# NOTICE OF DECISION

## DECISION OF THE HISTORIC LANDMARKS COMMISSION

MAJOR HISTORIC DESIGN REVIEW CASE NO. HIS17-34

**SUMMARY:** A proposal to replace the front porch, deck and windows at the Falk House (1876).

SOUTH ELEVATION

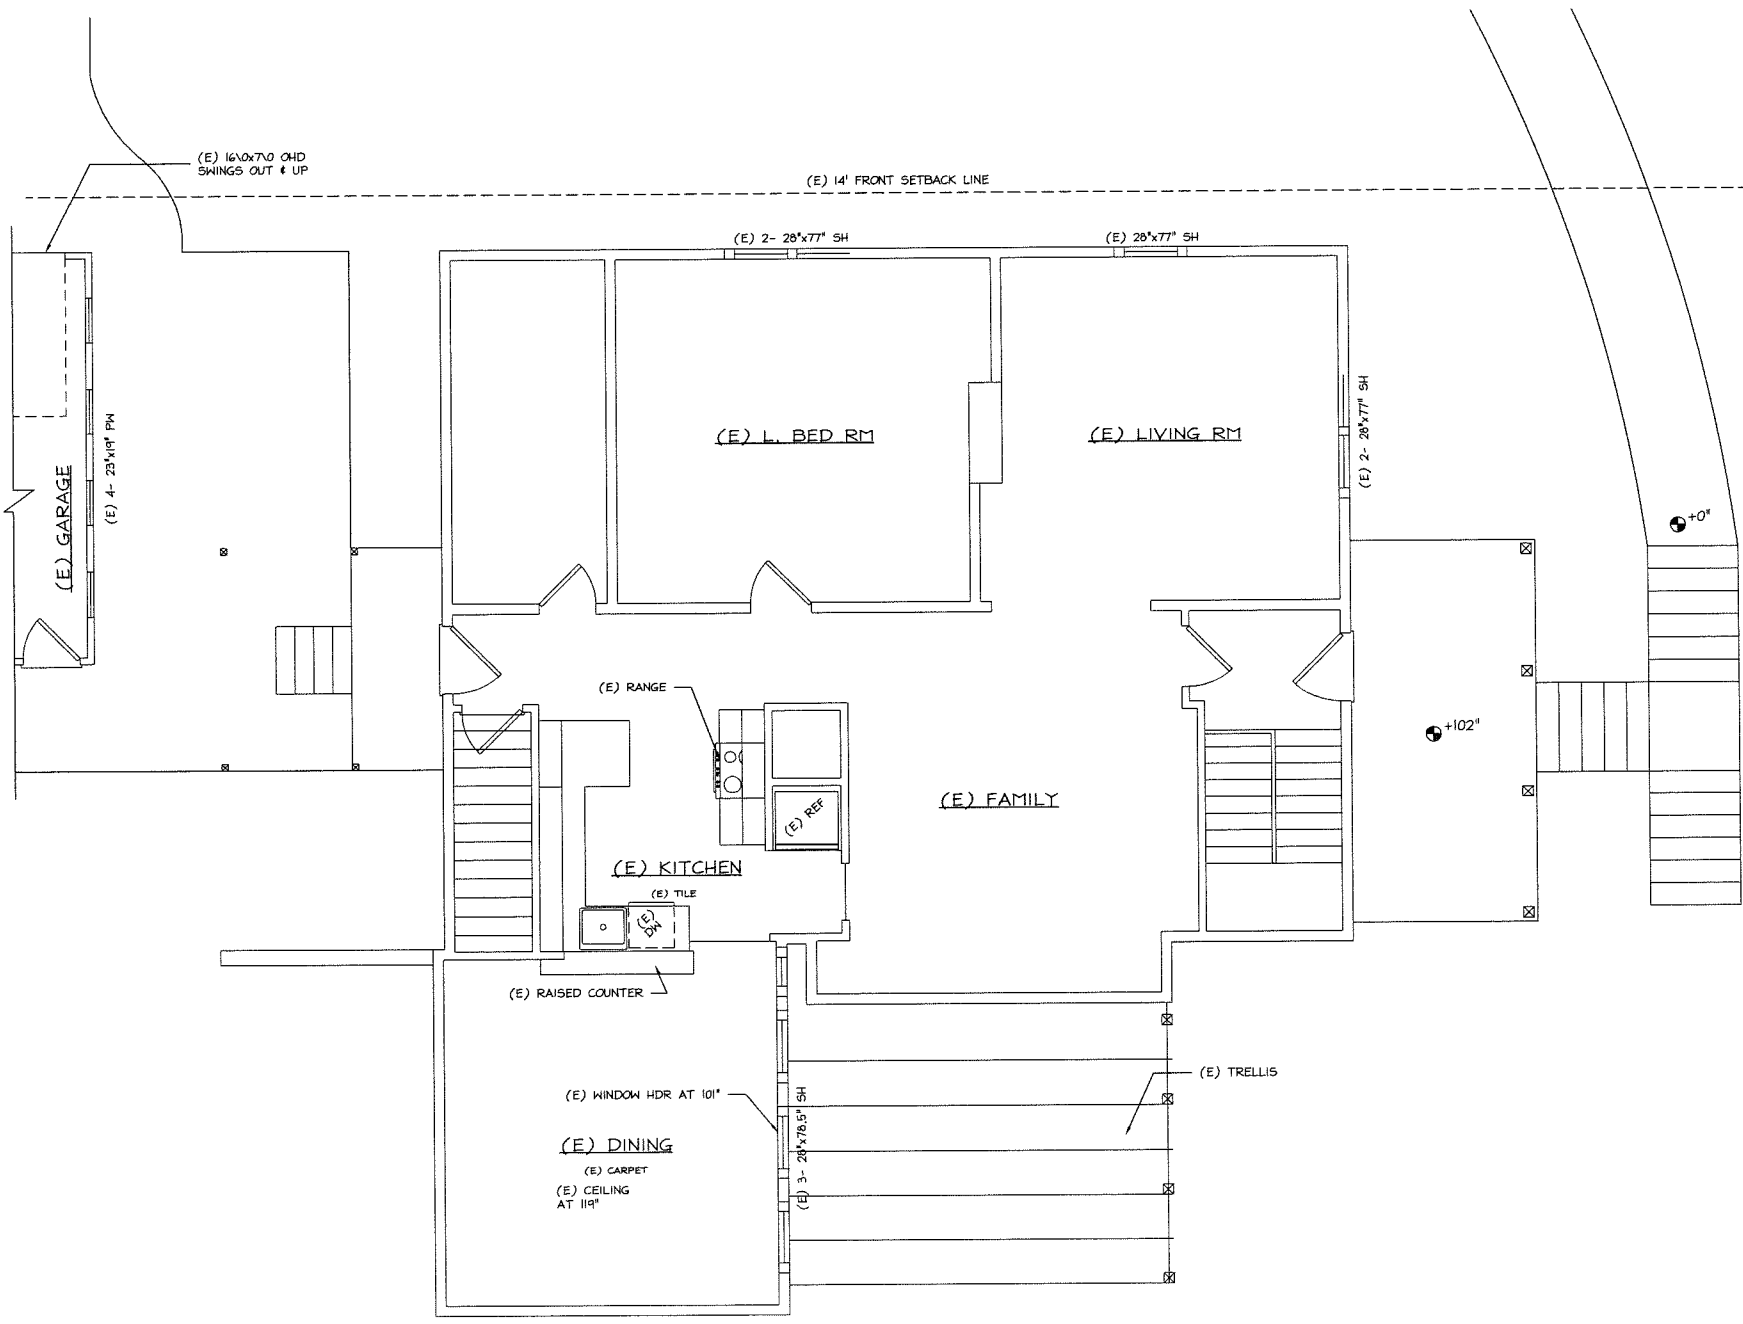
**Finding:** The HLC finds that the only alteration work the applicant is proposing is located at the rear of the building, and includes removal of two windows and the installation new French doors on the ground floor of the south façade. The remaining work relates to replacing existing features throughout the building which are in poor condition. The HLC finds that SRC 230.025(g)(2)(A) has been met.

**Finding:** The HLC finds that the applicant is proposing one alteration that is located at the rear of the building, and includes removal of two windows and the installation of new French doors on the ground floor of the south façade. The remaining work relates to replacing existing features throughout the building which are in poor condition. All the proposed new site work, including installation of new fencing, gate, and the retaining wall, are located at the rear and

REMOVE 2 (E) WINDOWS  
 AND INSTALL NEW FRENCH DOORS  
 SITE DETERMINE SIZES  
 ADD NEW 3.5x9 GLU LAM  
 HEADER
